TO: *mf* Marco Foster, MS473 54
THRU: *TRM* T. Madden / K. Klingman, NB82-230
FROM: *PF* P. Fuller / S. Beadle, NB 82-66
SUBJECT: C8 549
SR99, AWW Replacement North Access Connection
F.A. Project No: STPF-0099(122)
CHANGE ORDER 125
EN6, EN3A & EN3B Ductbank Changes

**WASHINGTON STATE
DEPARTMENT OF TRANSPORTATION
CHANGE ORDER**

CONTRACT NO: 008549 FEDERAL AID NO: STPF-0099(122)
 CONTRACT TITLE: SR 99, ALASKAN WAY VIADUCT - REPLACEMENT NORTH ACC
 CHANGE ORDER NO: 125 M-1, EN6, EN3A, EN3B DUCTBANK CHG

M-1 (818-9) PANEL VAULT (1)
SCALE: 1"=2'

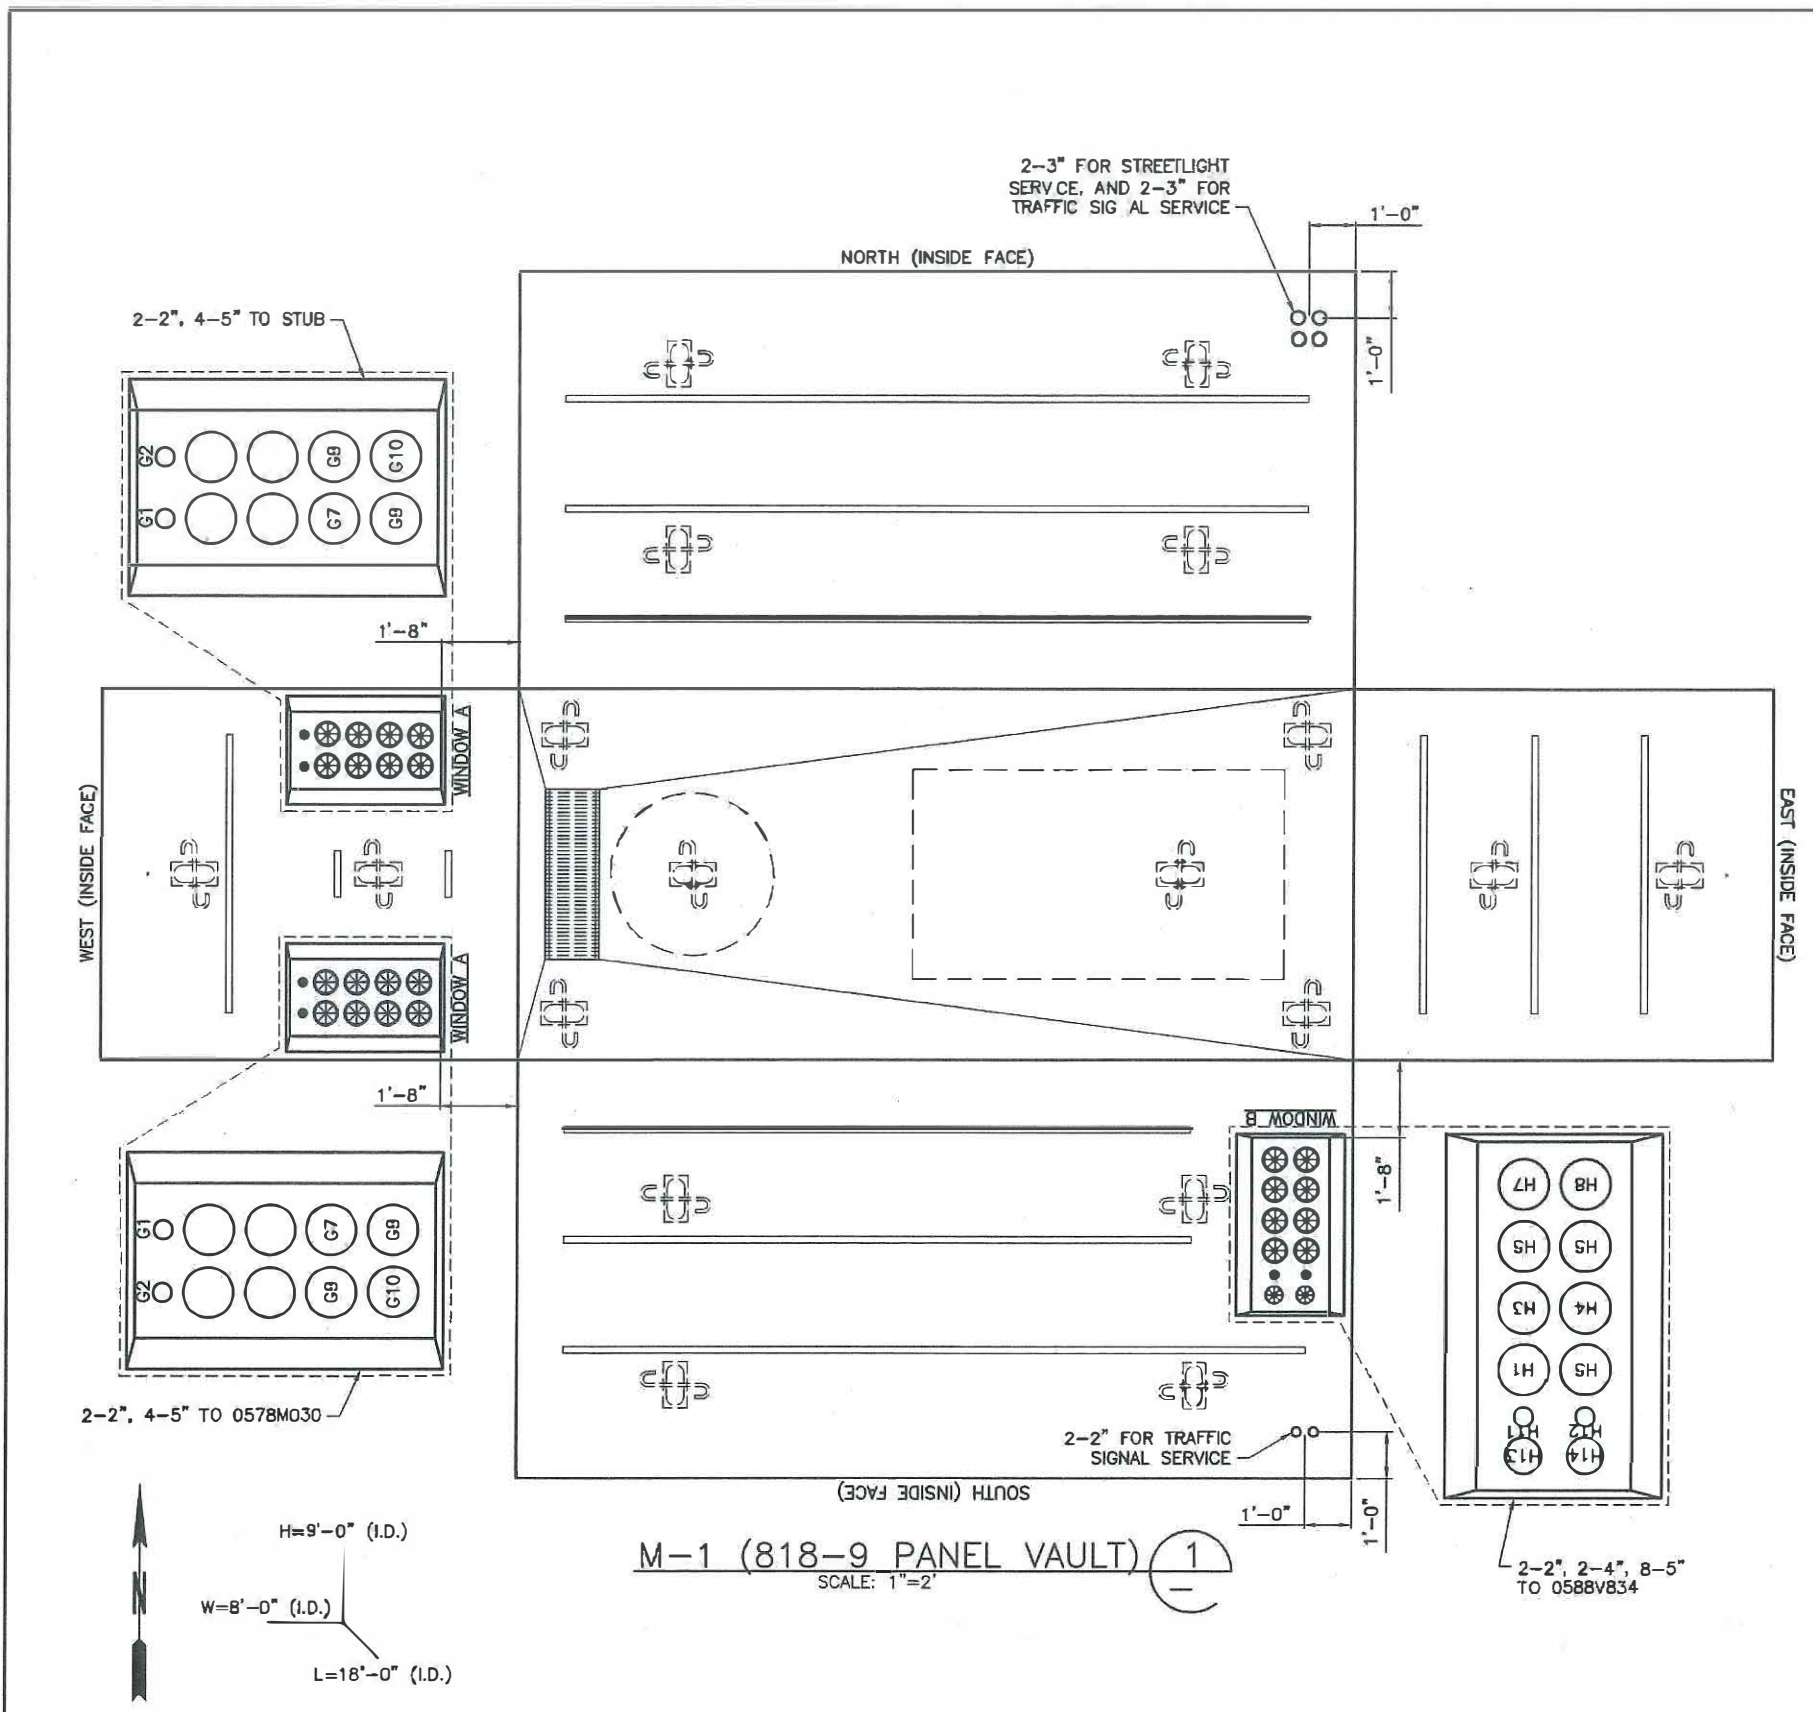
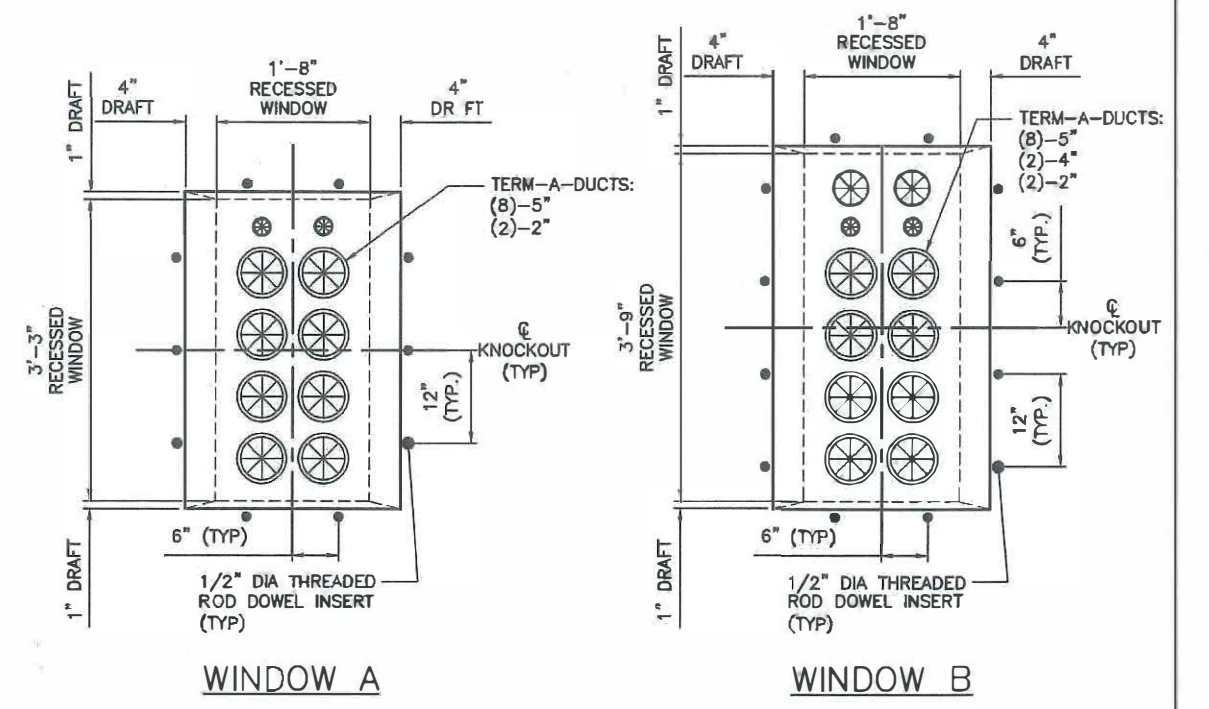
Adds the installation of the new M-1 vault at Station H-Line 97+07.27, (27.67' LT) as shown on UPN2, UP9, UP16, UPD19A, and UPD19B. The procurement and the shoring design of the M-1 Vault is included in C0150. This work consists of excavation, dirt export and disposal, vactoring, dewatering the excavation area, 2 ft. vault overexcavation and placing quarry spalls and bedding, importing quarry spalls and bedding, supporting in place vault V-XX5, removing C-XX3 vault and replace in kind, installing shoring system and procuring shoring materials, loading and unloading shoring system, setting the vault, mudding the vault, constructing a custom riser, removing shoring and backfilling, purchasing and placing CDF for backfilling, supporting existing utilities, mobilization and demobilization of equipment, survey and cleanup.

PRIOR TO M-1 VAULT INSTALLATION, CONTRACTOR SHALL VERIFY LOCATION OF ED3 AND ED4/5 DUCT BANKS TO CONFIRM THE EN6 PROFILE, PER DRAWING UPR10A

0588V834
~~0588M020~~ (EXISTING VAULT) (28) UP1
 SCALE: 1"=2'

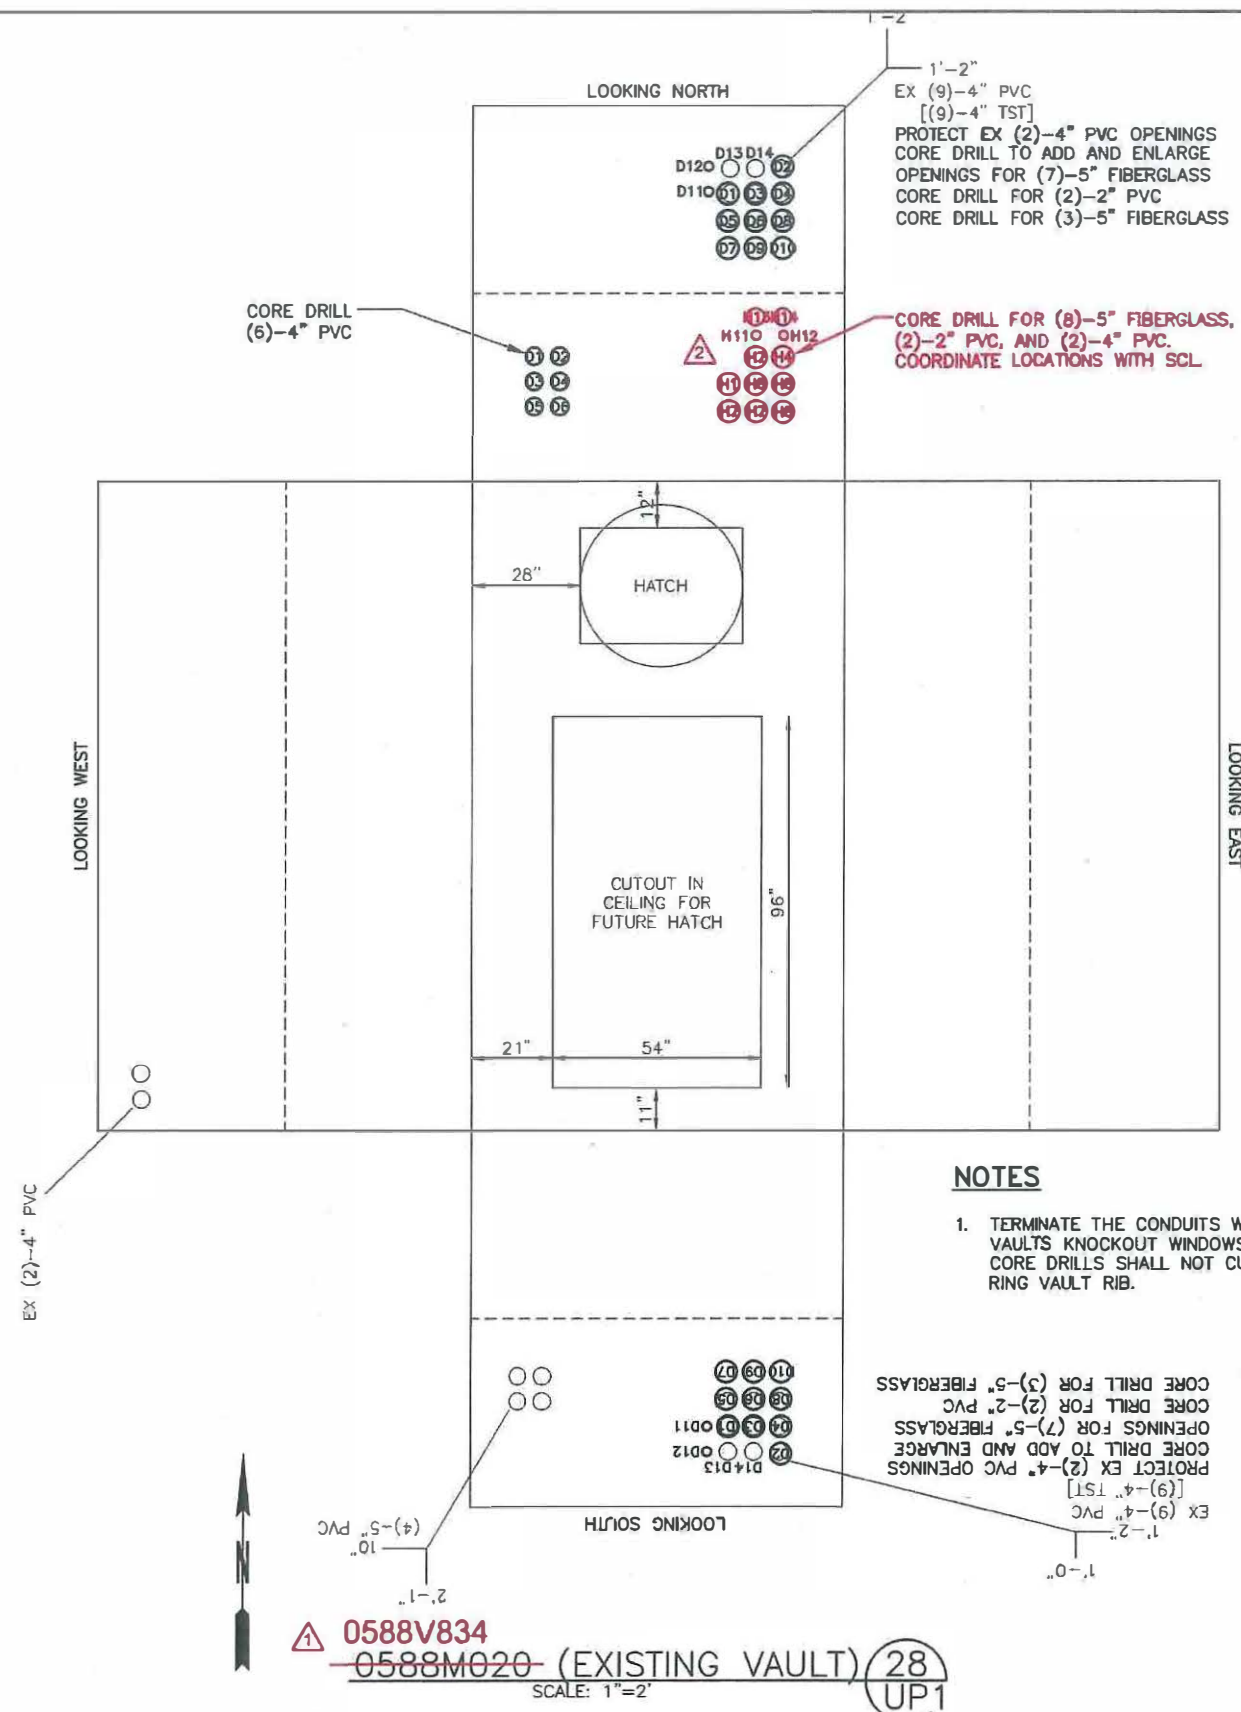
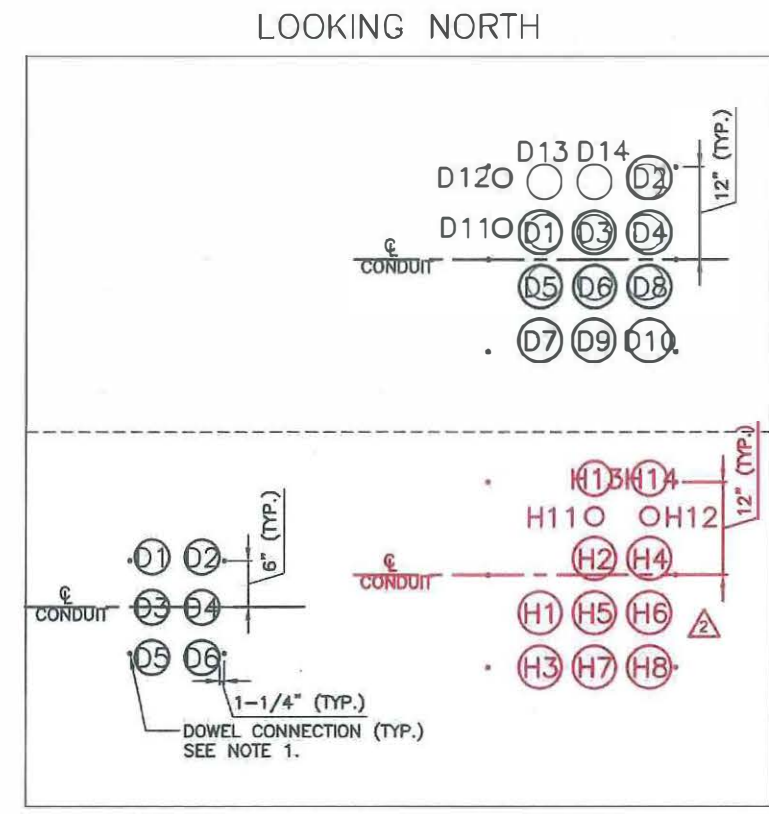
Adds new ductbank EN6 from station EN6 260+00.00 to 262+20.20 as shown on plans sheets UPAL1, UPT3, UP1, UP9, UP16, UPR2-UPR3, UPR7, UPR10A, UPD10, and UPD28. This work consists of excavation and shoring, procuring ductbank materials and installing them, placing high strength FTB, forming materials, setting forms and stripping, placing low strength FTB, chipping overpour at existing V-834, coring at V-834, dirt export and disposal, vactoring, dewatering the excavation area, 2ft overexcavation of trench and placing quarrying spalls and bedding, importing quarry spalls and bedding, supporting existing utilities which involves crossing live ductbanks at Harrison St. vicinity and supporting existing foundations, mobilization and demobilization of equipment, survey and cleanup.

1. DOWEL NEW DUCT BANK INTO EXISTING VAULT WALL TO PROVIDE SHEAR CONNECTION. DOWEL #4x16 STEEL REBAR INTO THE VAULT WALL WITH EPOXY (4" MIN. EMBEDMENT). FOUR DOWELS ARE REQUIRED FOR SIX CONDUITS OR LESS IN A DUCT BANK. SIX DOWELS ARE REQUIRED FOR MORE THAN SIX CONDUITS IN A DUCT BANK.
